PCN # ESW490-34 – TO-220AB non-isolated On Portfolio Thyristor Wafer Manufacture Site Transfer

# PCN Report

**Prepared By** : Lei Wu, Product Engineer  
**Date** : May 27th, 2020  
**Device** : Littelfuse WUXI TO-220AB non-isolated On Portfolio Thyristor Products  
**Revision** : B

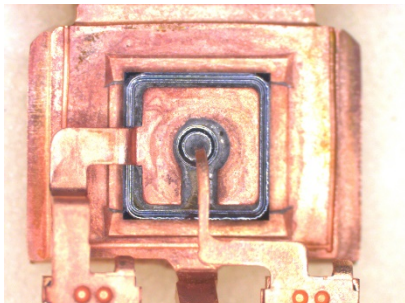
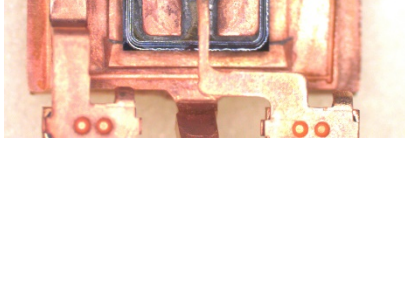
Internal assembly structure of new site wafers is slightly different with structure of existing wafers.  
 Details please refer to below list.

Existing	After	Affected Product Family
		MCR8Sxx/MCR72-xG/MCR310-xG/ C122F1G/MCR218-xG/2N639x/ MCR12xx/MCR68-xG series
		2N640x/MCR16xx/2N650x/MCR25xx/ MCR69-x/MAC8xx/MAC12xx/ BTB08-x00/BTB12-x00/BTB12H-x00/ MAC9xx/T2500/T2800/MAC228Ax/ MAC210Ax/2N634x/MAC3030-xG/ MAC15Ax/MAC16xx/BTB16-x00/ BTB16H-x00 Series
